E4417A-12A

S E R V I C E N O T E

Agilent E4417A EPM-P Peak & Average Power Meter

Front Panel Display Problems Caused by Power Assembly Cable

PSU cable assembly, E4418-61029

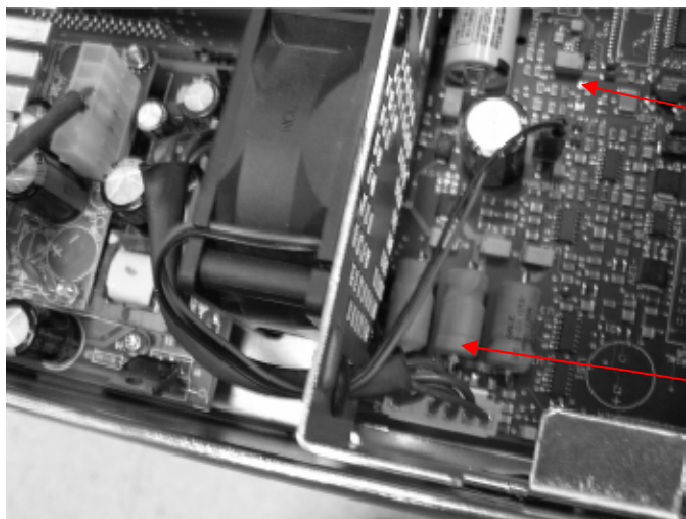
- 3) Remove fan connector and PSU cable assembly.

New cable with RED color

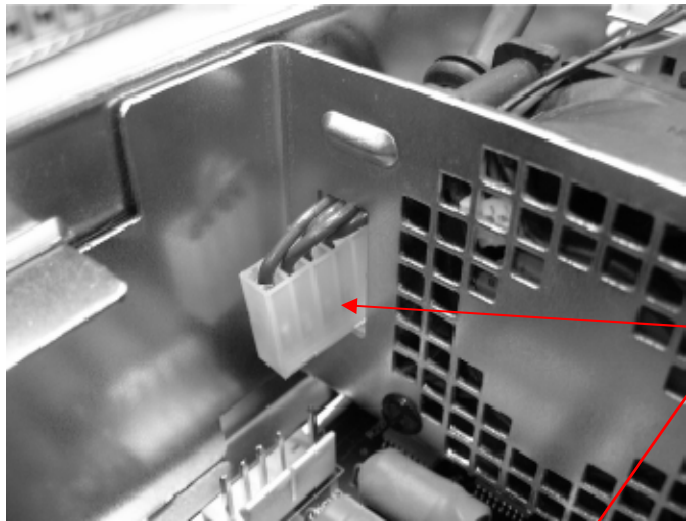
- 4) Replace with new PSU cable assembly E4418-61029. You can differentiate the cable assembly by the colors. The old cable is Black and new cable is RED.

Put back fan connector

Insert the plastic casing horizontally

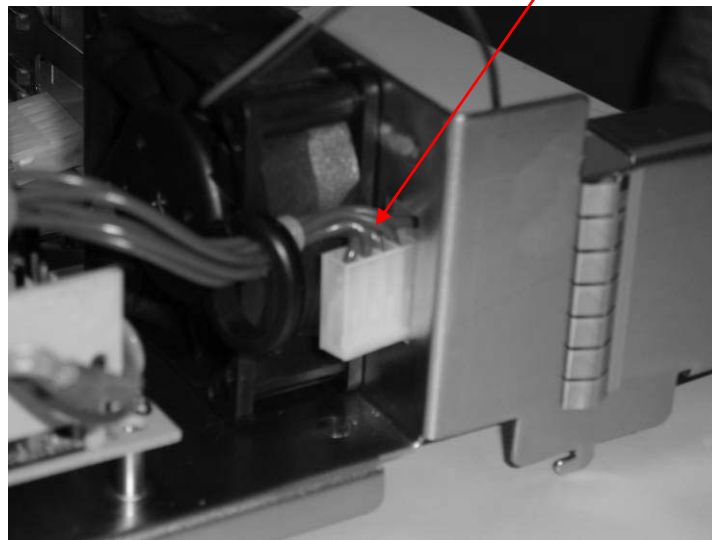
- 5) Here are some tips regarding the new cable. Since the plastic casing is slightly bigger in size, so you cannot directly pass through connector through hole. So you need to insert the cable horizontally. See illustration below.

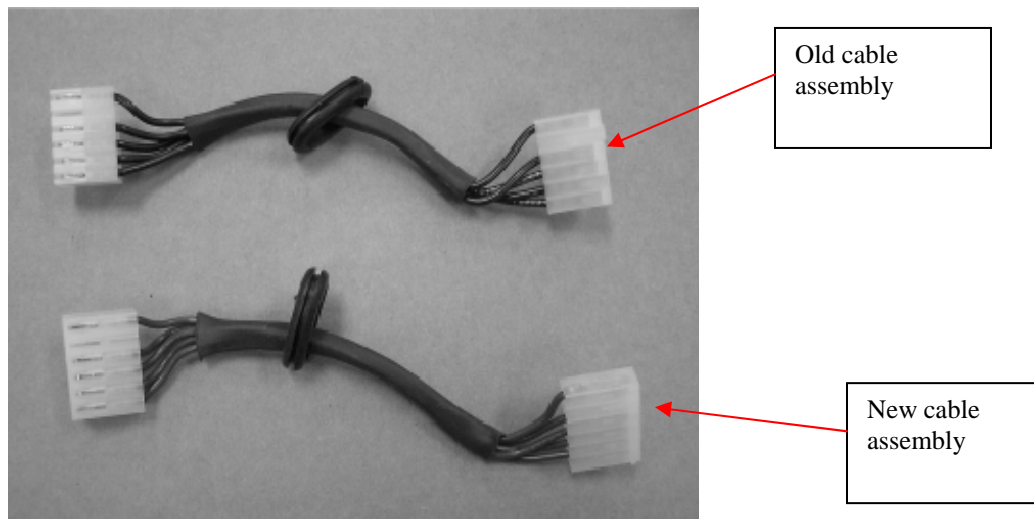
- 6) Photo below show different of old and new cable. The new cable is red in color whereas the old cable is black in color.

Note: If the power cable assembly is red in color, indicates that the cable already been changed. No action is needed.
